DOCUMENT 00 90 00
ADDENDUM

ADDENDUM NO. [1] **Date: January 30, 2020**

RE: **WITC – RICE LAKE CAMPUS**
PARKING AND SIGNAGE
1900 COLLEGE DRIVE
RICE LAKE, WI
HSR PROJECT NO. 19023-3

C2

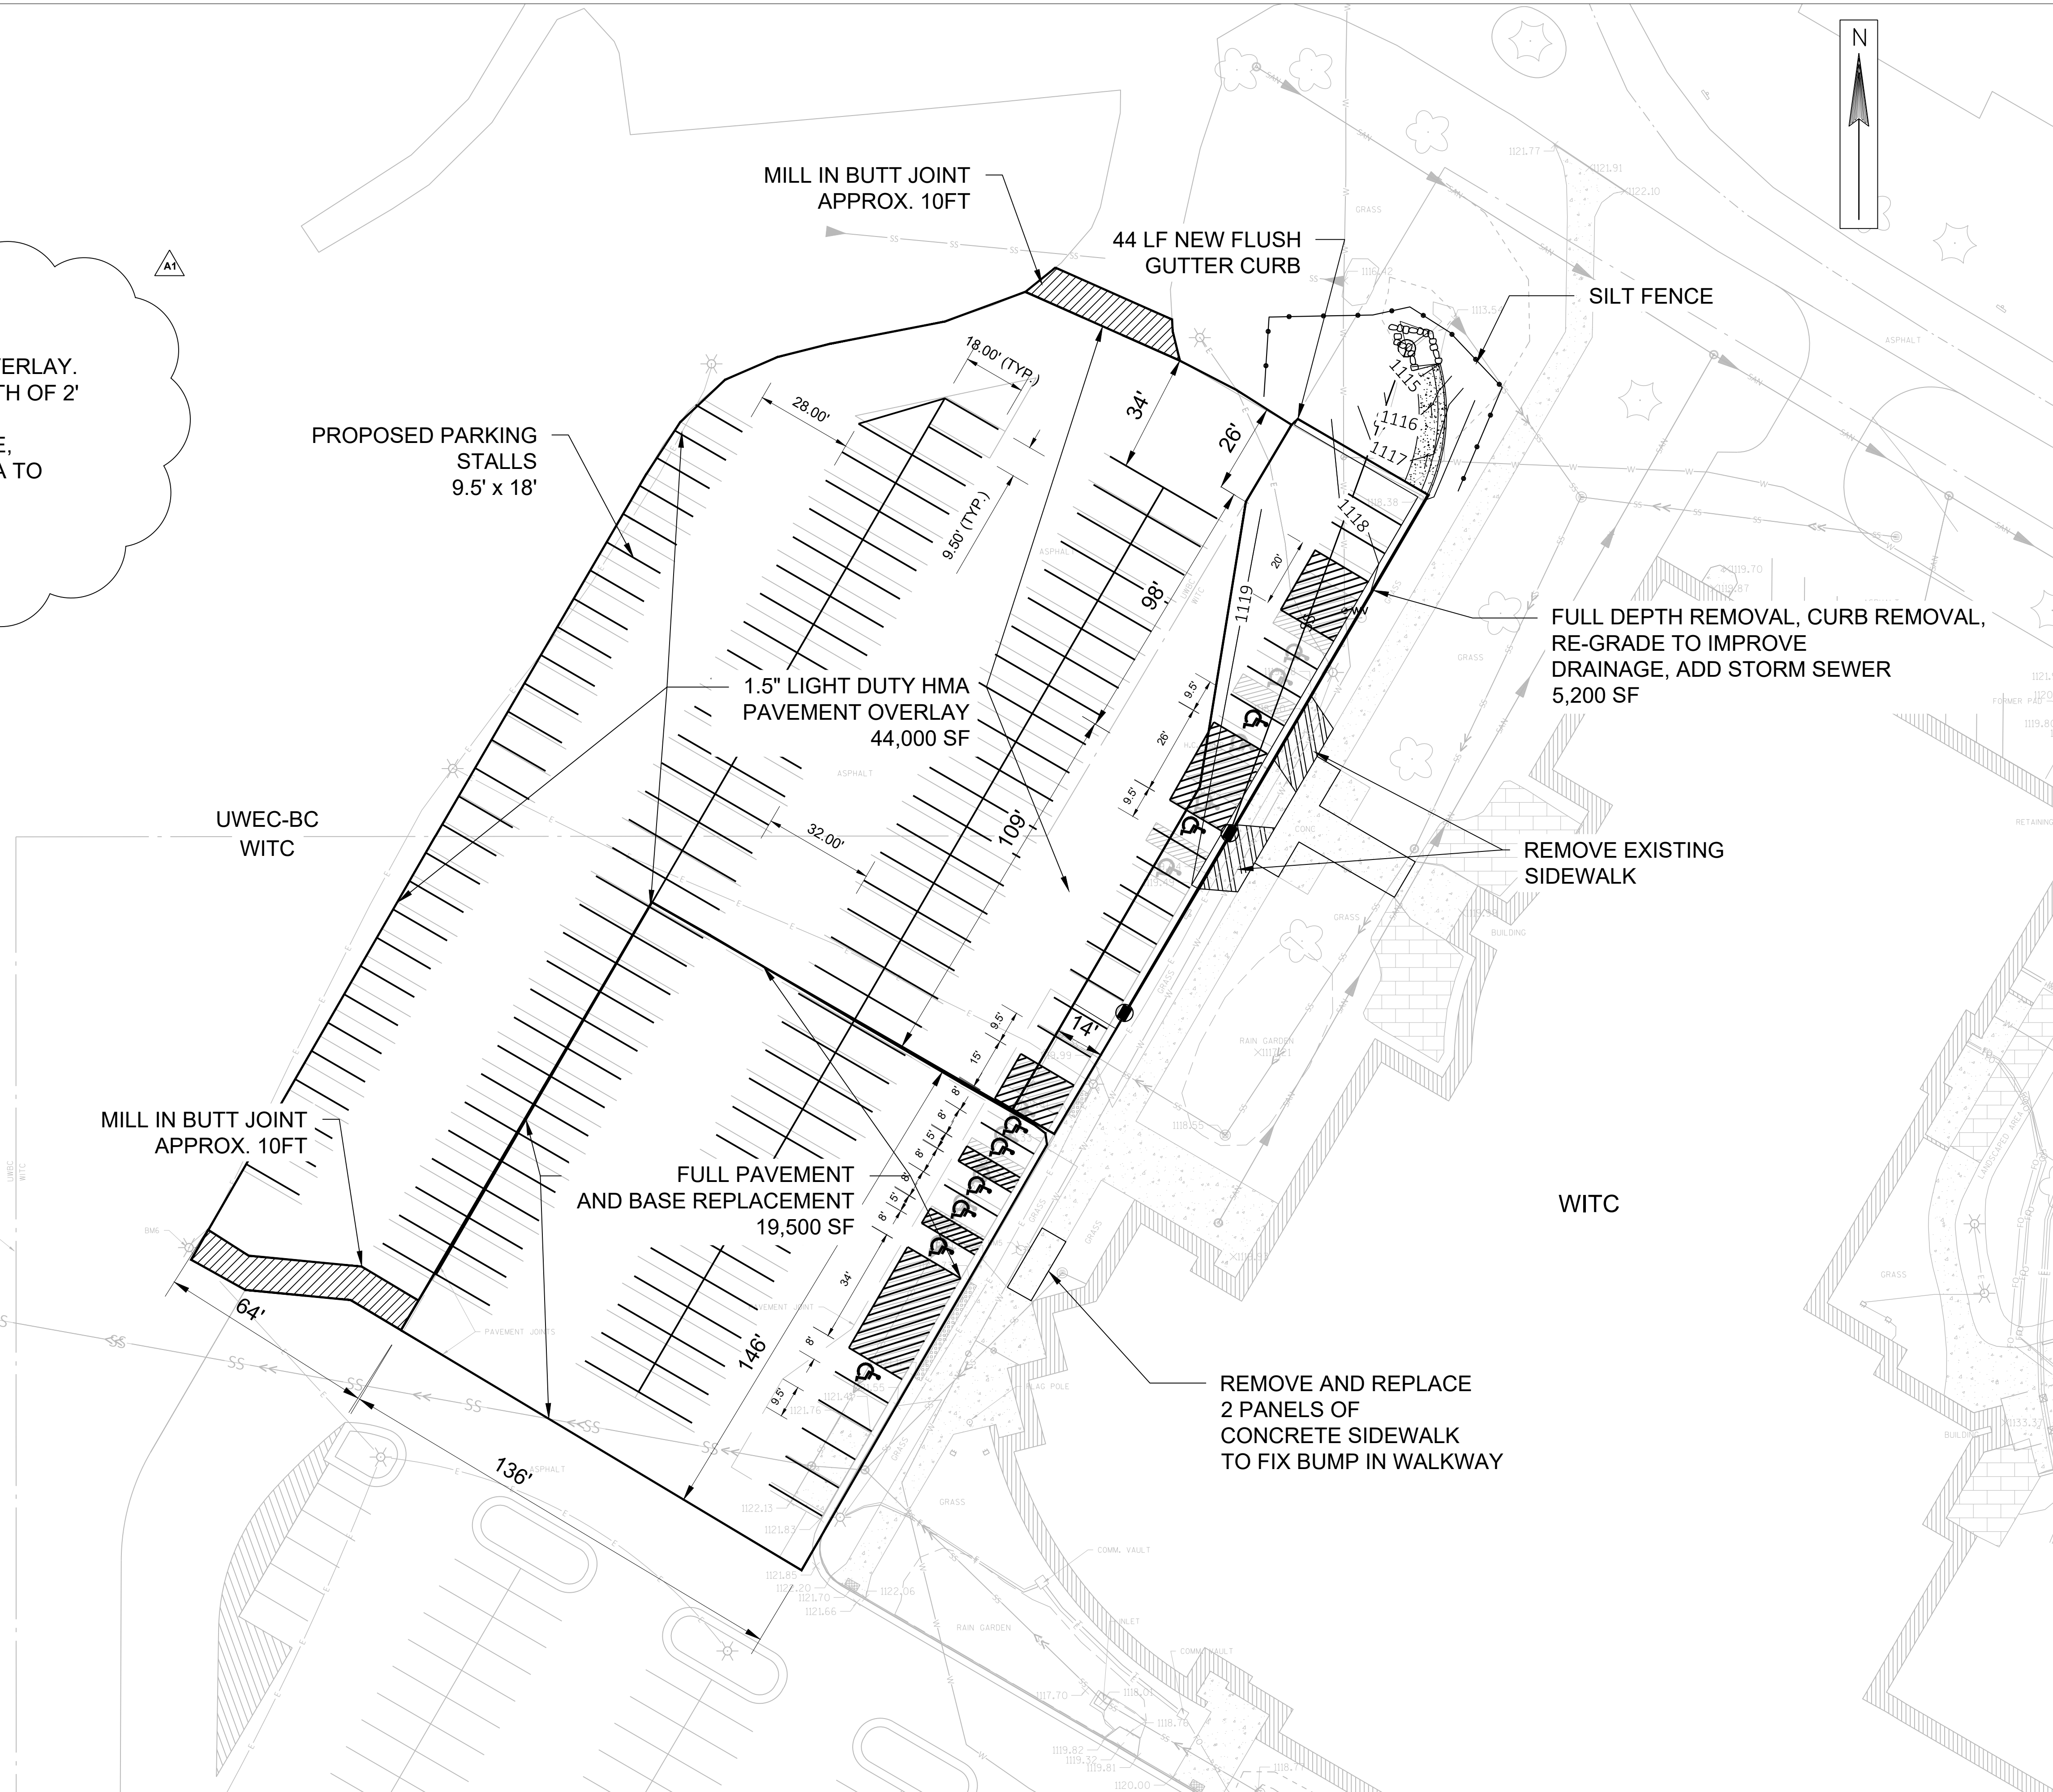
10. C2 PROPOSED NORTH LOT 24 x 36 attached hereto

- a. Revisions clouded on Drawing.

*** CRACK REPAIR PRIOR TO OVERLAY. REMOVE TO A MINIMUM WIDTH OF 2' WIDE. RECONDITION AND RE-COMPACT EXISTING BASE, PLACE NEW LIGHT DUTY HMA TO MATCH EXISTING PAVEMENT THICKNESS.

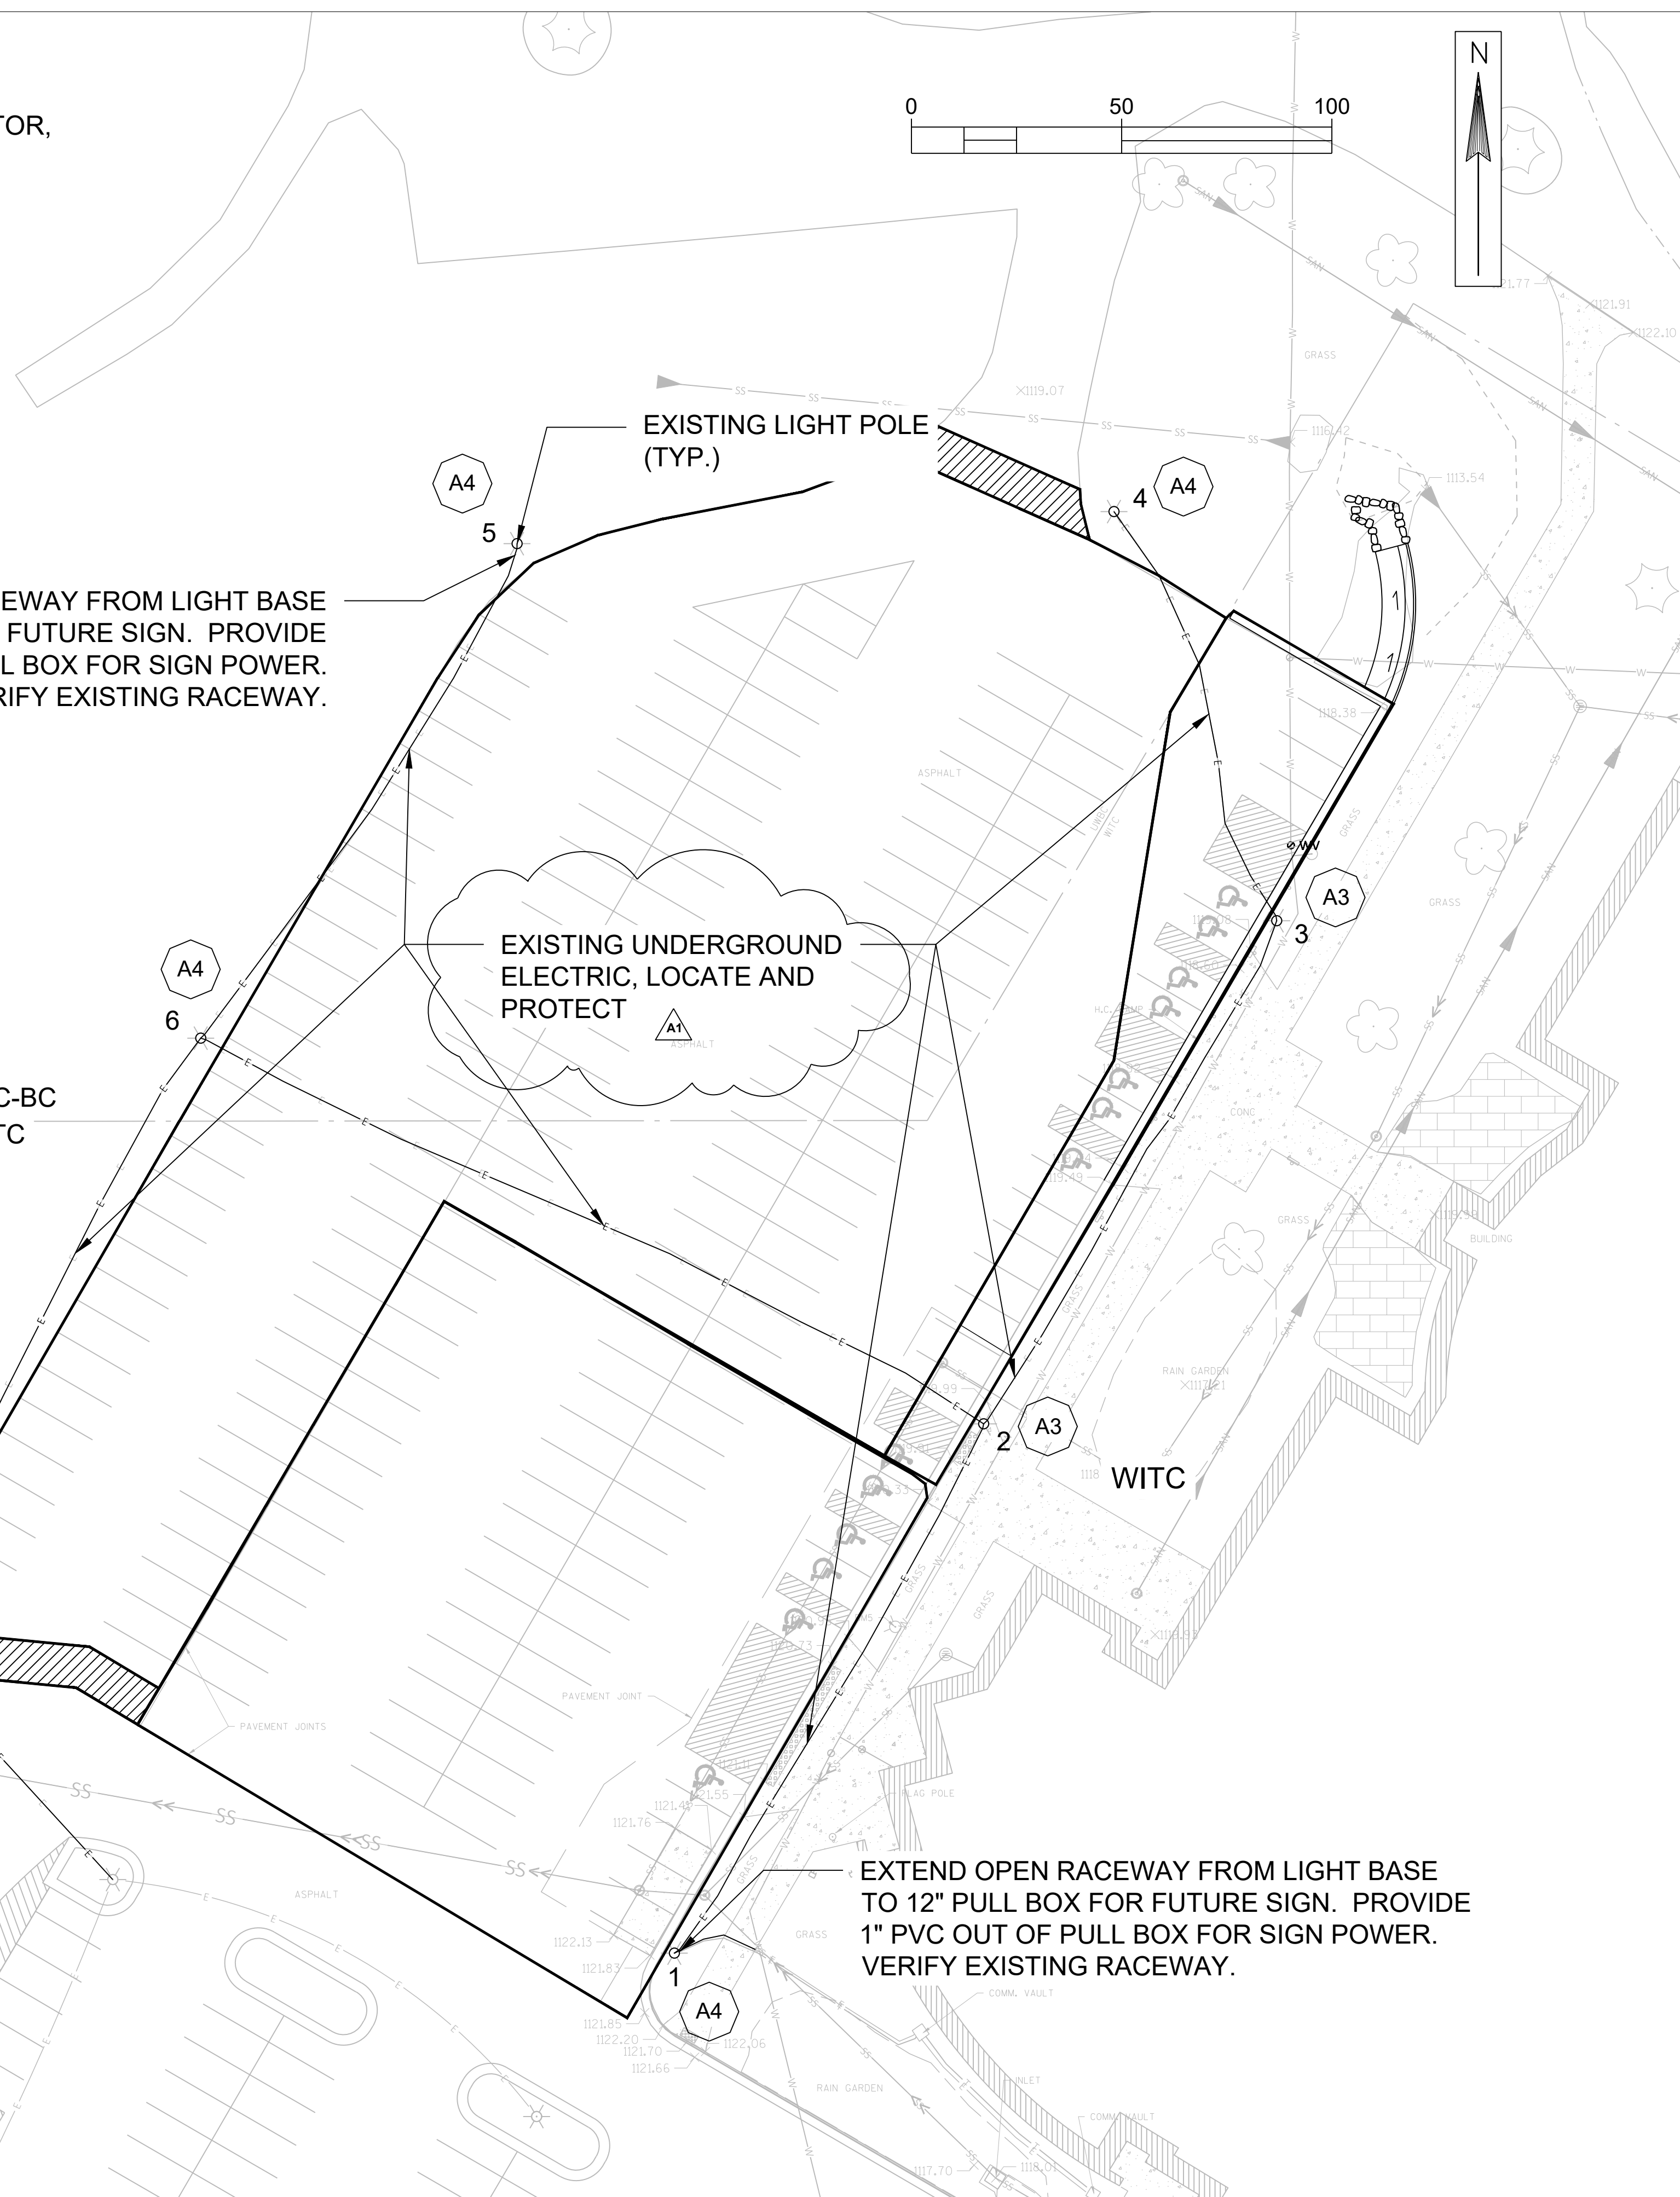
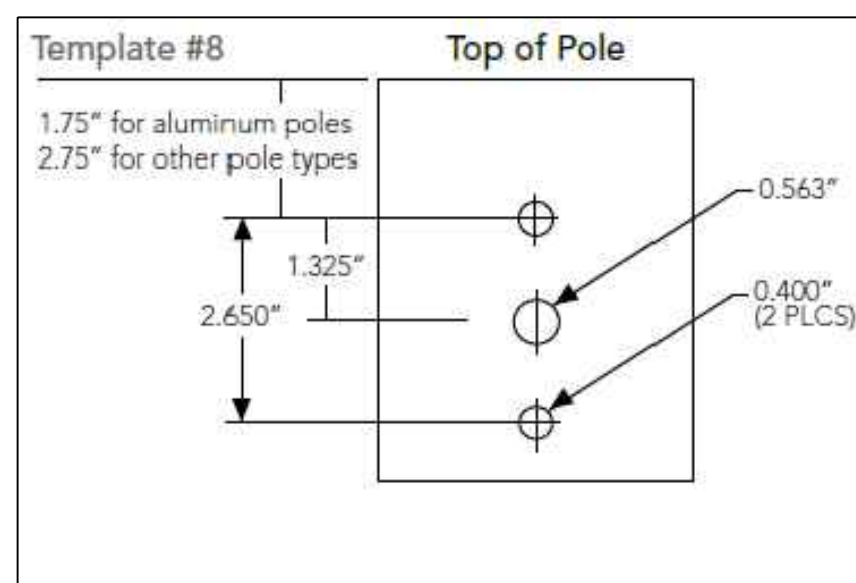
11. C5 P-NORTH LOT ELECTRICAL 24 x 36 attached hereto

- a. Revisions clouded on Drawing.

EXTEND OPEN RACEWAY FROM LIGHT BASE TO 24" x 36" PULL BOX FOR FUTURE SIGN. PROVIDE 1" PVC OUT OF PULL BOX FOR SIGN POWER. VERIFY EXISTING RACEWAY.

EXTEND OPEN RACEWAY FROM LIGHT BASE TO 12" PULL BOX FOR FUTURE SIGN. PROVIDE 1" PVC OUT OF PULL BOX FOR SIGN POWER. VERIFY EXISTING RACEWAY.
